Access Compliance Report

Public Rights-of-Way

(Curb Ramps)

Intersection ID: 11672	Main Street: CARTWRIGHT_PL	Cross Street: KEMPTON_PL	Location: NW
ADA ID: 710A3ABE6A4F	Ramp Type: Perp	Initial Pass/Fail: Pass	Overall Compliance: No
		Severity Score: 0

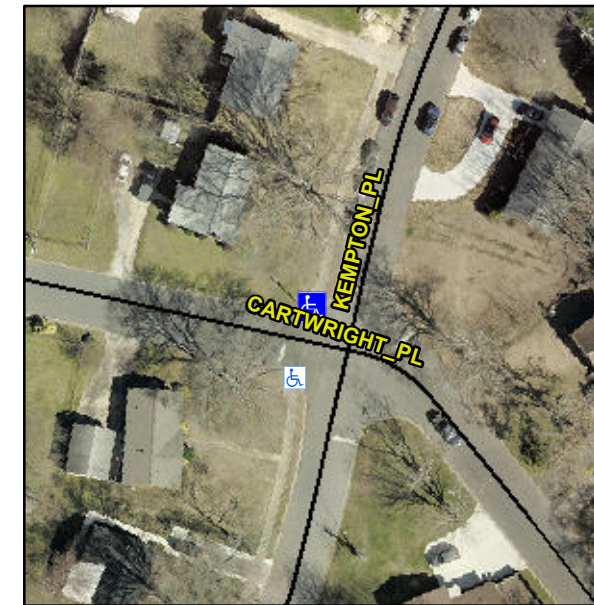
Possible Solutions:

Not Found, R304.2.1

Remove & Replace Entire Ramp.
